PLANNING RESPONSE TO HARRINGTON ISSUES REGARDING OVERSHADOWING AND BUILDING HEIGHT

RPS have been requested by TSA Management to prepare a detailed response to the Harrington submission to the Catherine Field Primary School SSDA dated 10 December 2019. This response letter is separate to the Response to Submissions Report that has been prepared by RPS as part of the SSDA process.

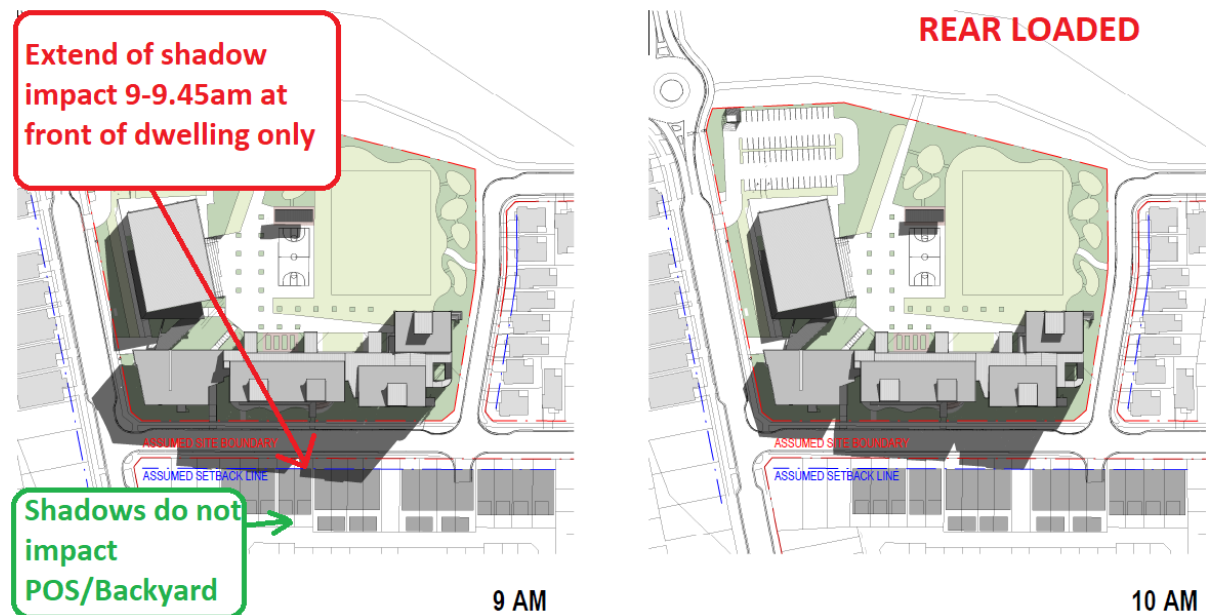
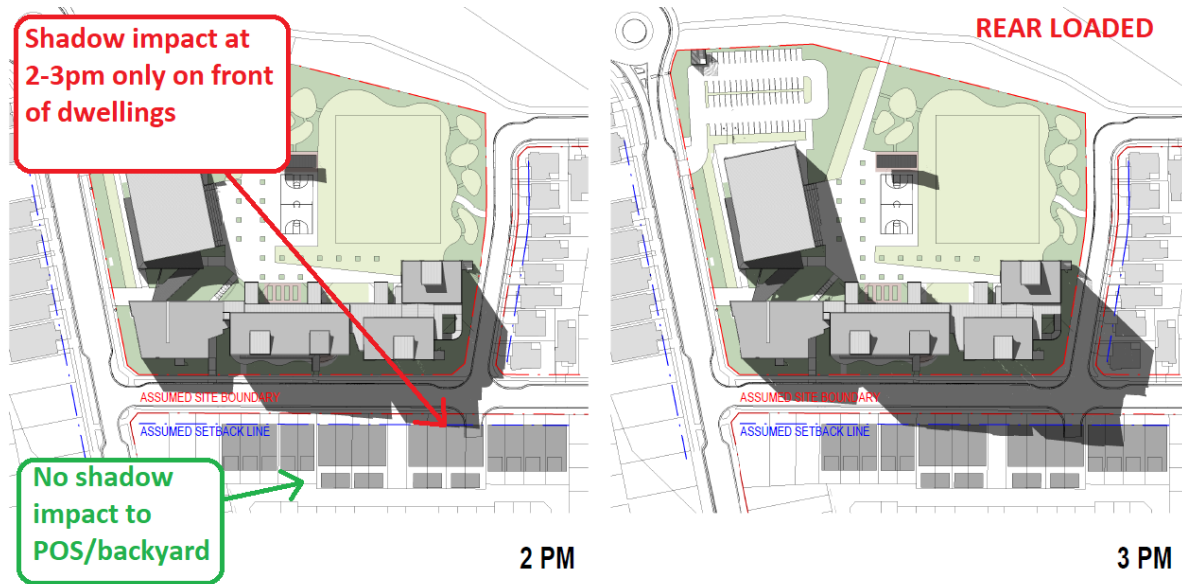
As shown on the shadow diagrams, the shadow from the school will have a minimal impact on the dwellings themselves. The impact is limited to the very front portion of 9 dwellings between 9am to 9.45am, and then on a mostly different set of 10 dwellings between 2pm and 3pm (see below marked up diagrams for reference). The first set of dwellings that is impacted for 45 minutes in the morning, will receive uninterrupted solar access for the remainder of the day. The set of 10 dwellings that is impacted for 1 hour in the afternoon, will receive uninterrupted solar access until 2pm. This length of impact is minor and well within typical controls for solar access to dwellings which require 2-3 hours to living rooms between 9am and 3pm at mid winter.

These future dwellings firstly, are unlikely to have their living rooms impacted at all because the shadow falls only on the front portion of the dwelling and the living rooms would most likely be at the rear facing the backyards, and secondly, the length of impact is so minor that they would receive at least 5 hours mid winter solar access nevertheless.

Accordingly, the shadowing impact to the dwellings and their PPOS is very minor and easily compliant with the applicable control.
